Errata to TFP101(A), TFP201(A), TFP401(A), TFP403, Datasheet Literature Numbers SLDS116A, SLDS119C, SLDS120B, SLDS125A

Revision History

1. PowerPAD dimension.

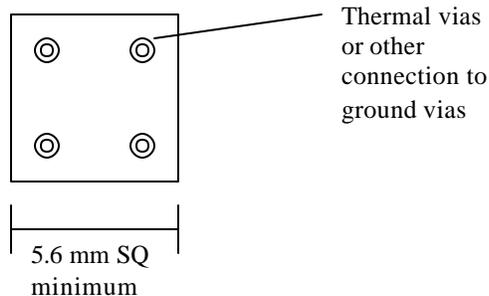
ISSUE:

The previous data sheet PowerPAD dimensions were not shown. Those have been added as a new sheet in the current data sheet under the title ‘Thermal Pad Mechanical Data’.

Changes to document:

In the “PowerPAD...” section, add a sentence to paragraph 1, reword paragraph 2 and add figure and paragraphs between existing paragraphs 2 &3 to read:

... Soldering the back side of the ... to the application board is not required thermally as the device power dissipation is well within the package capability when not soldered. If traces or vias are located under the back side pad, they should be protected by suitable solder mask or other assembly technique to prevent inadvertent shorting to the exposed back side pad.

Soldering the back side pad of the device to a thermal land connected to the PCB ground plane is recommended for electrical and EMI considerations. The thermal land may be soldered to the exposed PowerPAD using standard reflow soldering techniques.

The recommended pad size for the grounded thermal land is 5.6mm sq. minimum, centered in the device land pattern. When vias are required to ground the land, multiple vias are recommended for a low impedance connection to the ground plane. Vias in the exposed pad should be small enough or filled to prevent wicking the solder away from the interface between the package body and the thermal land on the surface of the board during solder reflow.
